Access Compliance Report Public Rights-of-Way (Curb Ramps)

Main Street: SHIVELY_RD		Cross Street: RANUNCULUS_ST		Location:	SW
ADA ID: RPRK211111114459	Ramp Type: Type 4 - Parallel	Initial Pass/Fail: Fail	Overall Compliance: No	Severity Score:	30

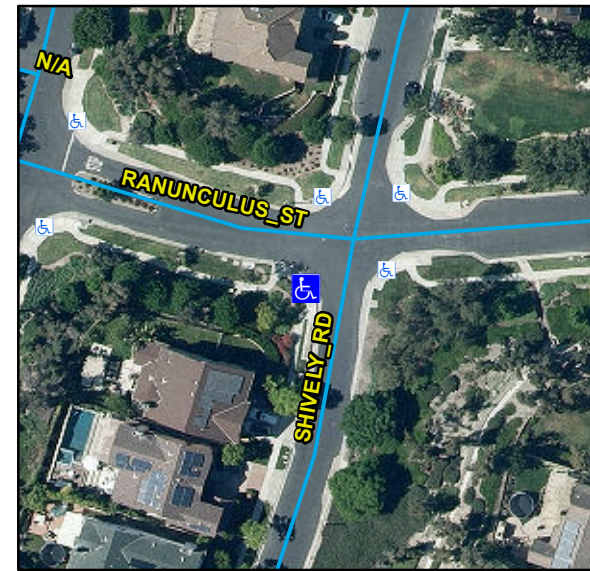
Compliance	Description	Data	Compliance	Description	Data
N/A	Ramp Length LT (in)	132	N/A	Ramp Length RT (in)	144
Yes	Ramp Width LT (in)	53	Yes	Ramp Width RT (in)	53
No	Ramp Run Slope LT (%)	14.7	Yes	Ramp Run Slope RT (%)	5.4
Yes	Ramp Cross Slope LT (%)	0.1	Yes	Ramp Cross Slope RT (%)	0.5
N/A	Landing Present	N/A	N/A	DWS Provided	N/A
N/A	Landing Length (in)	N/A	N/A	DWS Contrast	N/A
N/A	Landing Width (in)	N/A	N/A	DWS Length (in)	N/A
N/A	Landing Run Slope (%)	N/A	N/A	DWS Full Width	N/A
N/A	Landing Cross Slope (%)	N/A		DWS Offset Type	N/A
N/A	Landing Movement Obstructed?	N/A	N/A	DWS Offset Left (in)	N/A
	Landing Movement Type	N/A	N/A	DWS Offset Right (in)	N/A
N/A	Landing Shared	N/A			
N/A	Clear Space	Yes			
N/A	Clear Space To Crosswalk (in)	N/A			
N/A	Marked Crosswalk 1	No	N/A	Marked Crosswalk 2	No
	Crossing 1 Direction	E		Crossing 2 Direction	N
N/A	Marked Crosswalk 1 Width (in)	N/A		Marked Crosswalk 2 Width (in)	N/A

N/A	Ramp Inside Crosswalk 1	N/A	N/A	Ramp Inside Crosswalk 2	N/A
	Crossing 1 Slope (%)	5.8		Crossing 2 Slope (%)	4.1
	Crossing 1 Cross Slope (%)	5.8		Crossing 2 Cross Slope (%)	9.9
N/A	Gutter Ponding	N/A	N/A	Curb Slope	6
Yes	Gutter Lip Height (in)	0		Road Run Slope (%)	9.7
N/A	Gutter Run Slope (%)	N/A		Road Cross Slope (%)	8.9
N/A	Gutter Cross Slope (%)	N/A	No	Perpendicular Joint Present	No
Yes	Overall Surface Condition	Acceptable			
	Cross Gutter Present?	No		Spandrel Present?	No
	Replace Cross Gutter?	N/A		Replace Spandrel?	N/A

Remove & Replace Curb Ramp With Two New Directional Ramps or Equivalent.

R204.3, R304.3.2, STD 1115
